# UNITED STATES PATENT AND TRADEMARK OFFICE

APPLICATION NO.	FILING DATE	FIRST NAMED INVENTOR	ATTORNEY DOCKET NO.	CONFIRMATION NO.
10/522,855	07/01/2005	Minoru Yamamoto	122383	5238
25944	7590	05/10/2007		
OLIFF & BERRIDGE, PLC P.O. BOX 19928 ALEXANDRIA, VA 22320			EXAMINER MCCLAIN, GERALD	
			ART UNIT 3653	PAPER NUMBER
			MAIL DATE 05/10/2007	DELIVERY MODE PAPER

<b>Office Action Summary</b>	Application No. 10/522,855	Applicant(s) YAMAMOTO ET AL.	
	Examiner Gerald W. McClain	Art Unit 3653

## DETAILED ACTION

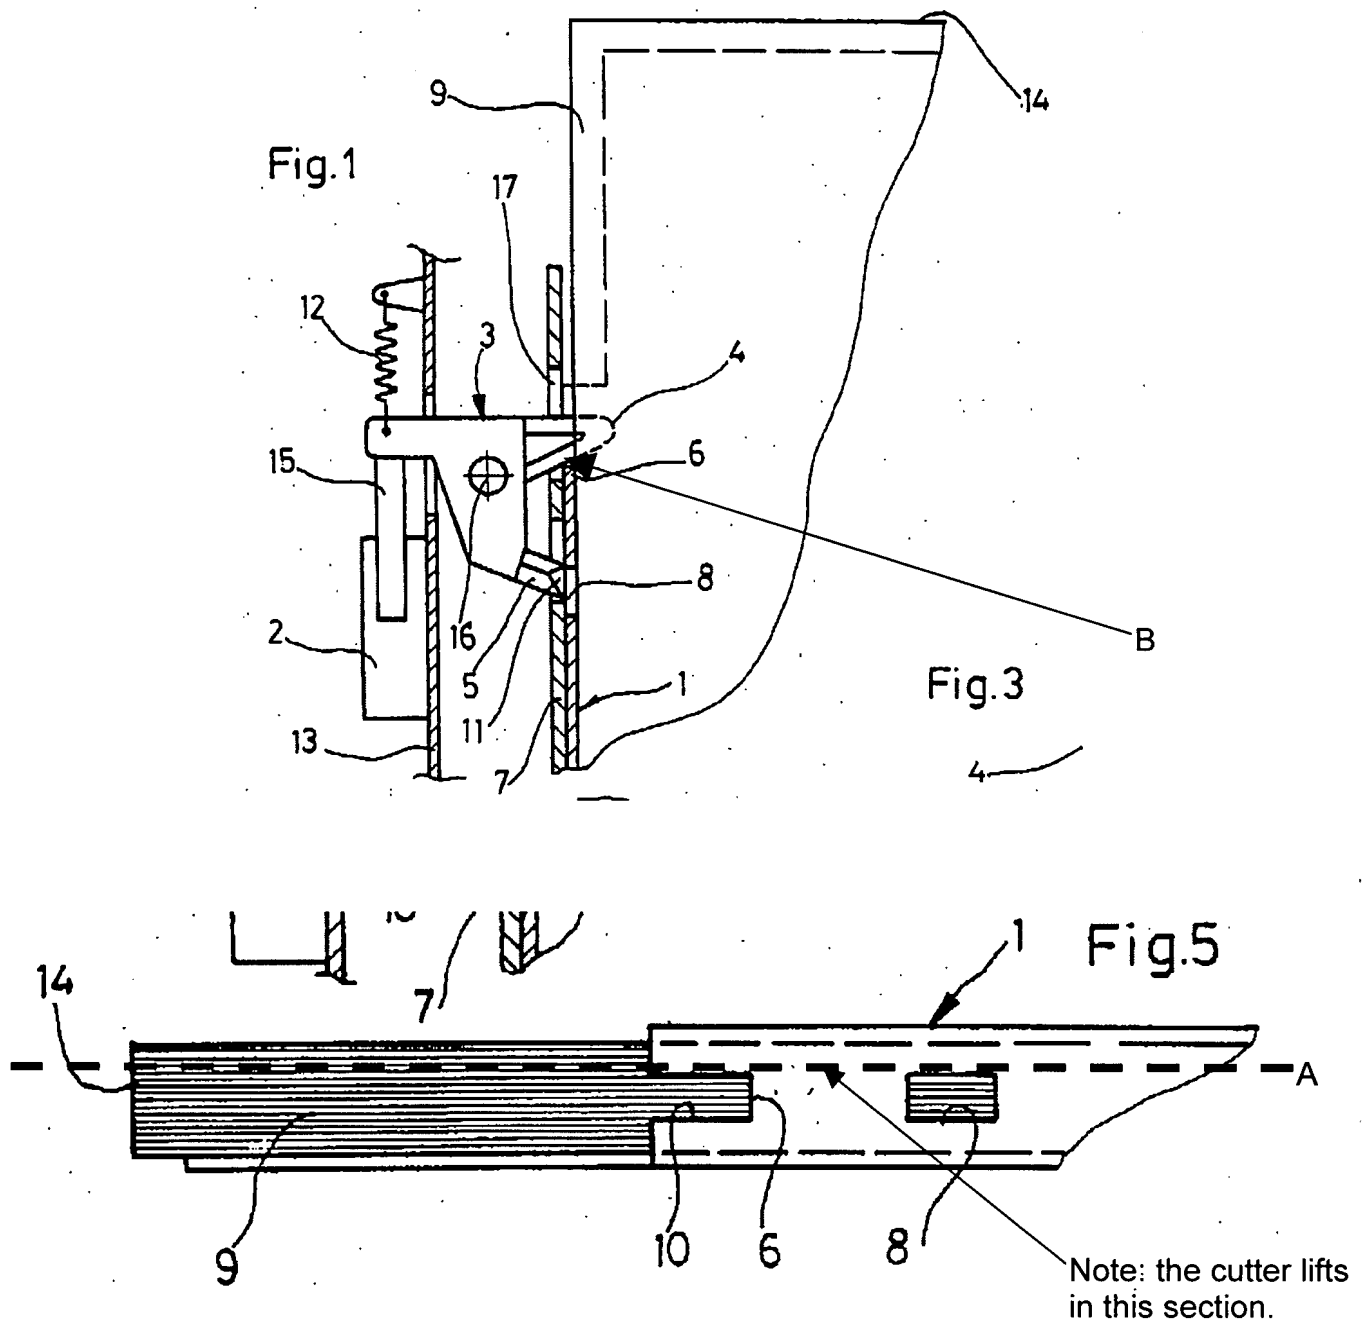
Claims 1 and 16-17: package member (1); sheet package (1); printer (abstract; a copying machine *inherently* has a printer element); side part (1 along which 6 is part); edge (6); sheet storage unit (7); projecting part (3);

Claims 2 and 3: package member (1); perforated line (See Fig. 5 below, line A); side part into two parts (8 and 10 sections); (Note: the method of making an apparatus structure is not considered in apparatus claims.)

Claim 5: pressing member (3); concave part (17 and 18; Note: the part detail is not shown. However, any cut is *inherently* concave at some point on its profile.); side wall of the sheet storage unit (7); side part (8 and 10); pushing member (4 and 11);

Claim 9: projecting part (3); level difference (See Fig. 1 below, B level; Note: B is "formed in" 7 since B passes through 7.); side wall of the sheet storage unit (7); side part (1 along which 6 is part);

FIG. 6

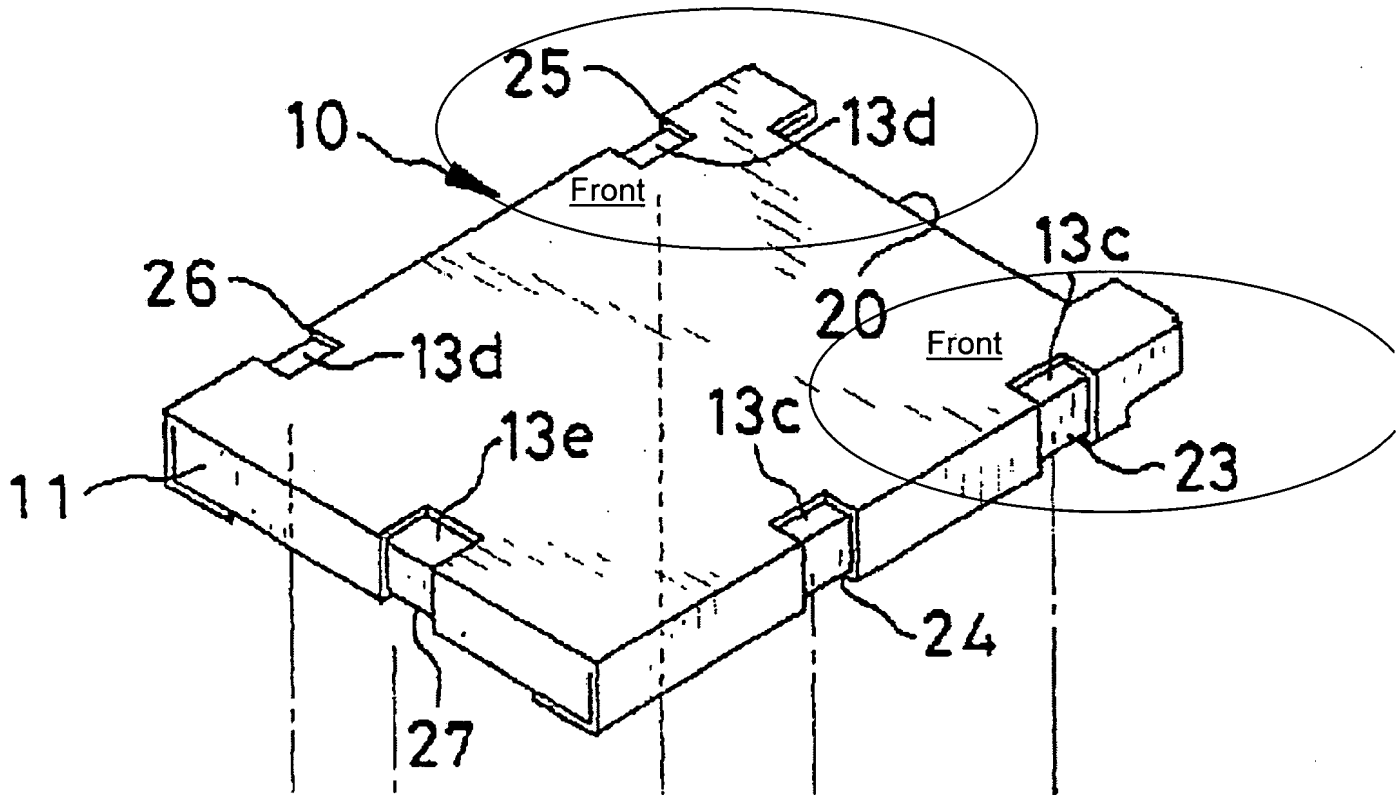
Claims 1 and 16-17: package member (10); sheet package (10); printer (abstract); side part (23 and 25); edge (23 and 25; See FIG. 6 below, note that the front sections are identified in regions.); sheet storage unit (40); projecting part (55);

Claim 9: projecting part (55); level difference (See FIG. 6, 50 and 52); side wall of the sheet storage unit (55 at 40); side part (23 and 25);
